METROPOLITAN GOVERNMENT OF NASHVILLE AND DAVIDSON COUNTY

STAFF RECOMMENDATION
1517 Paris Avenue
June 20, 2012

Application: New construction-addition, Partial demolition, and Setback reduction
District: Belmont-Hillsboro Neighborhood Conservation Zoning Overlay
Council District: 18
Map and Parcel Number: 11704026900
Applicant: Van Pond, architect
Project Lead: Robin Zeigler, robin.zeigler@nashville.gov

<p>Description of Project: Applicant proposes a rear addition which will extend beyond the right side wall of the house and requires a side setback reduction. The addition will require the removal of a rear chimney and rear dormer. Alterations are also planned for the existing house and found to be appropriate.</p> <p>Recommendation Summary: Staff recommends approval of the addition, partial demolition, exterior alterations and setback reduction at 1517 Paris Avenue with the conditions that the applicant provide final details about windows and doors to staff for review and the addition be a minimum of two inches (2') shorter than the existing house. Staff finds that the project meets sections II.B. of the design guidelines for New Construction and Additions in the Belmont-Hillsboro

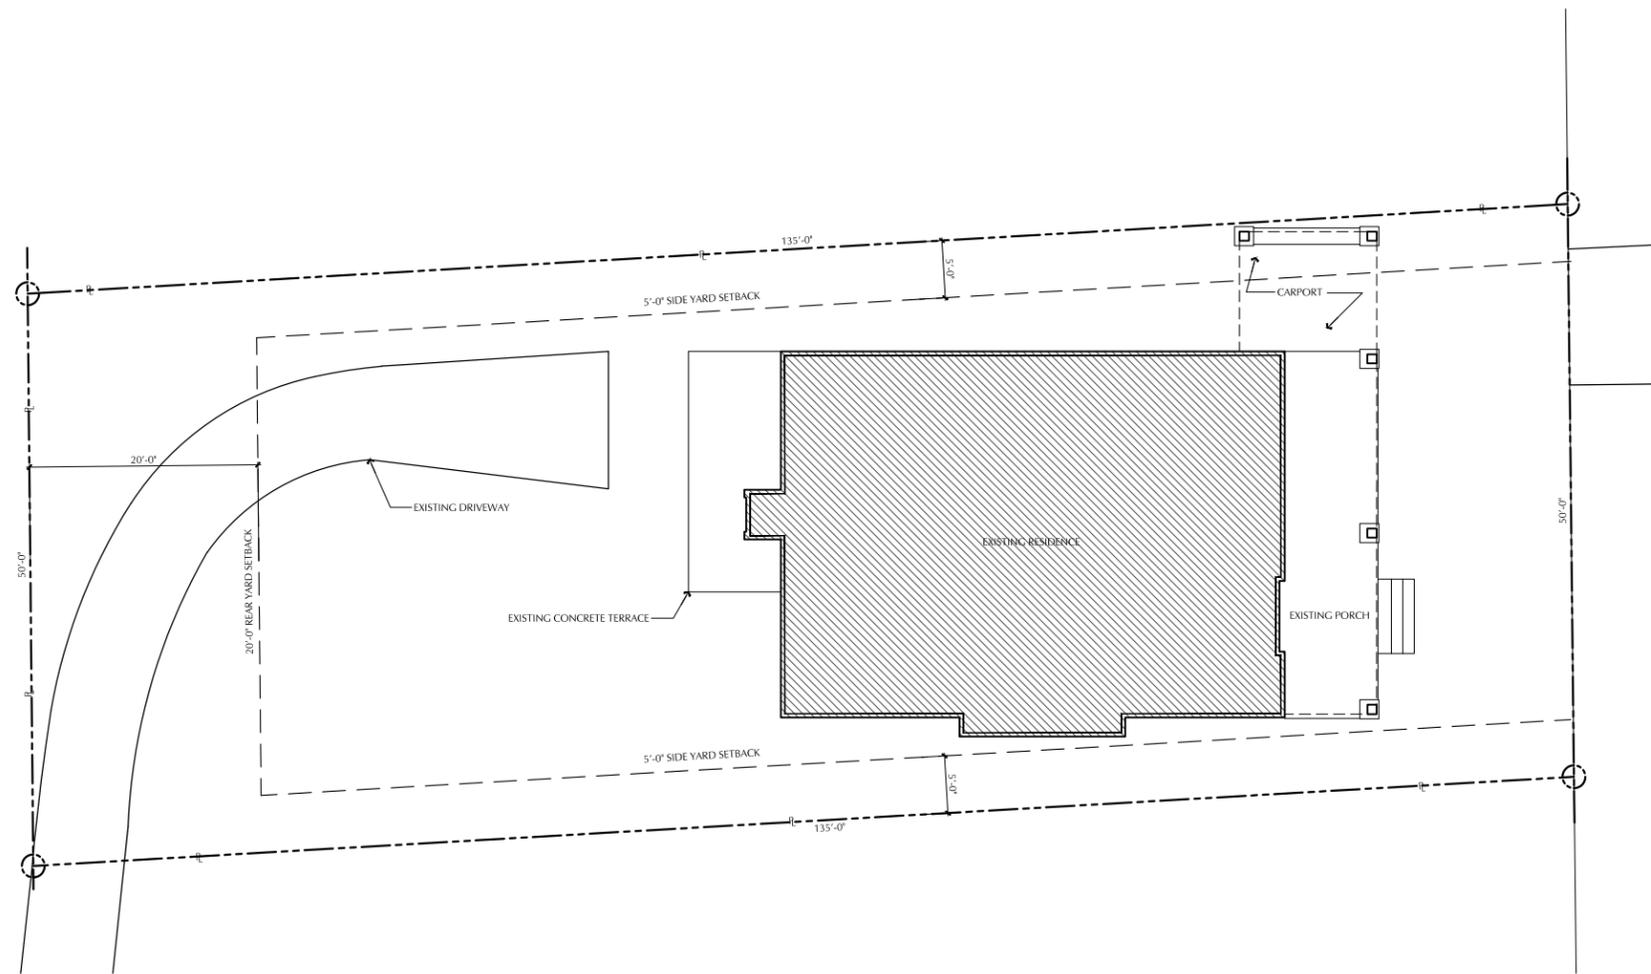
Removal & Partial Demolition: Because of the addition's attachment points both to walls and to the roof, it could easily be removed in the future without changing the existing form of the house. The rear chimney, rear dormer, and the brick wall between the outer pedestals of the porte cochere will be removed; however, neither is a character defining feature. The front chimney will remain.

Brick wall to be removed.
